## Architect's Supplemental Instructions

**PROJECT:** *(name and address)*  
17-13 OSU College of Med. at Hastings  
Tahlequah, OK

**ASI INFORMATION:**  
ASI Number: Bid Pack 03 - ASI 01  
Date: 4/22/19

**Bid Package 03- ASI 01 – OSU College of Osteopathic Medicine At The Cherokee Nation**

**C5 PERIMETER FOUNDATION SECTION**  
SCALE: 3/4" = 1'-0"

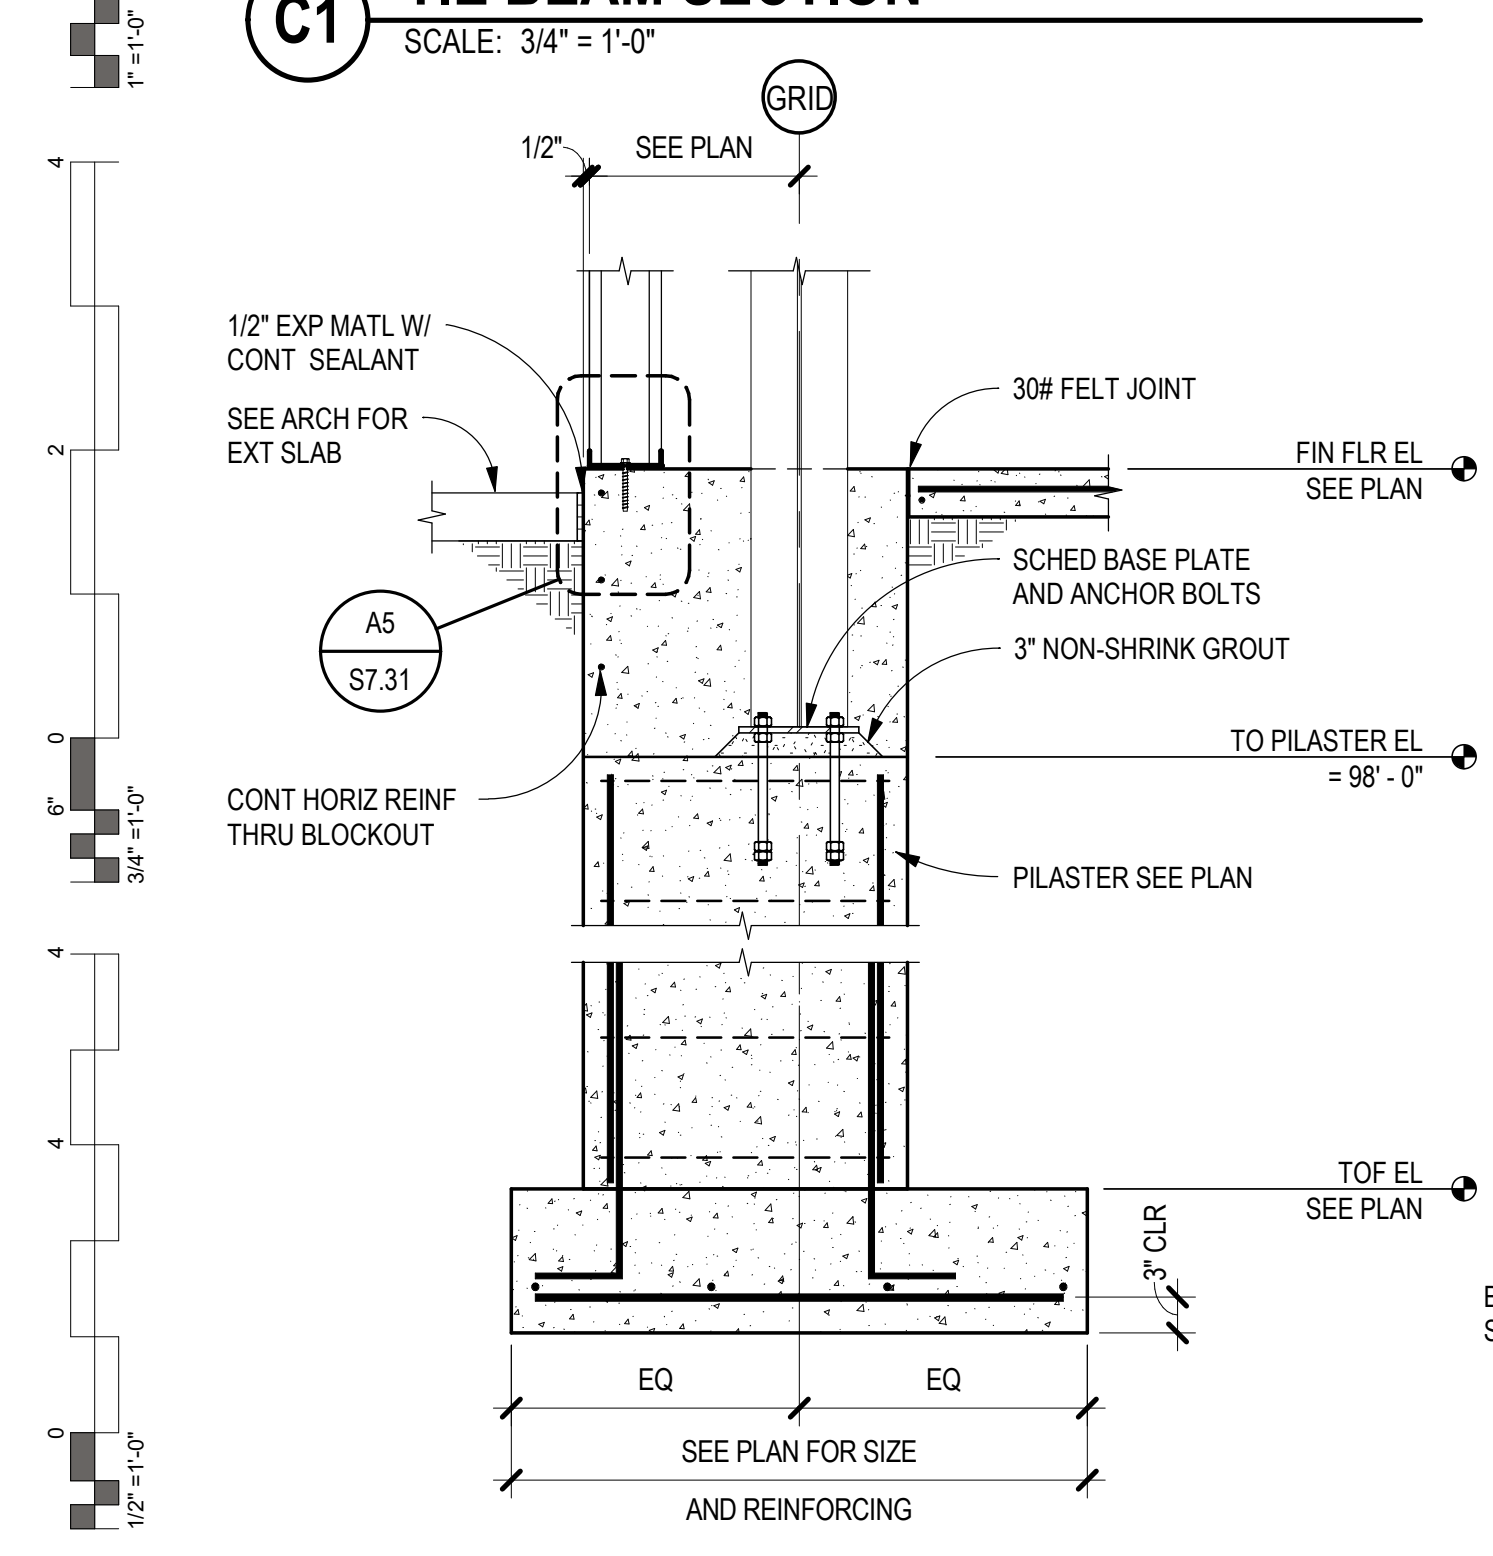
S3.11	Entire sheet revised.
S3.12	Detail D5 revised.
S4.02	Canopy support post size and quantity along Grid 1 revised.
S4.02	Canopy support beam sizes along Grid 1 revised.
S4.02	Thickened slab added to plan A4.
S5.11	Detail D1 added.
S6.01	Slab-on-grade schedule revised.
S6.01	Spot footing and continuous footing schedules revised.
S6.01	Detail A1 revised.

ENTIRE SHEET REVISED
